APPLICATION NO.	FILING DATE	FIRST NAMED INVENTOR	ATTORNEY DOCKET NO.	CONFIRMATION NO.
10/692,865	10/27/2003	Toshihito Yanashima	020265A	9185
23850	7590	09/17/2004	EXAMINER	
ARMSTRONG, KRATZ, QUINTOS, HANSON & BROOKS, LLP			NGUYEN, HANH N	
1725 K STREET, NW			ART UNIT	
SUITE 1000			PAPER NUMBER	
WASHINGTON, DC 20006			2834

Office Action Summary	Application No. 10/692,865	Applicant(s) YANASHIMA ET AL.	
	Examiner Nguyen N Hanh	Art Unit 2834

DETAILED ACTION

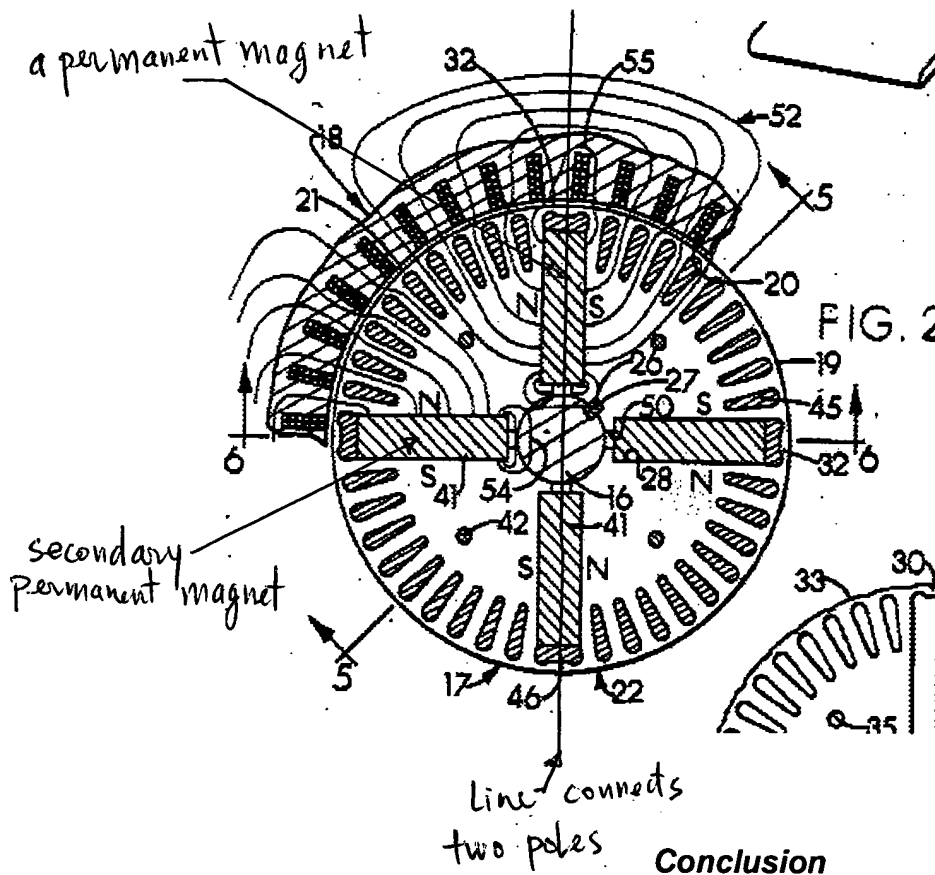
Regarding claim 10-12, Kapadia discloses a synchronous induction motor comprising: a stator (18 in Fig. 2) equipped with a stator winding; a rotor (17) which is secured to a rotating shaft (16) and which rotates in the stator; a secondary conductor (45) provided around the rotor yoke constituting the rotor; and a permanent magnet (42) embedded in the rotor yoke, wherein a magnetic field (52) produced by the permanent magnet does not pass through the rotating shaft (bypass the rotating shaft as in claim 11 or passes through only the rotor yoke, excluding the rotating shaft as in claim 12); comprising secondary permanent magnets provided symmetrically about a line that connects two magnetic poles, wherein the secondary permanent magnets have lengths which are radially disposed, and wherein the secondary magnets are substantially adjacent to the rotating shaft (please see markups below).
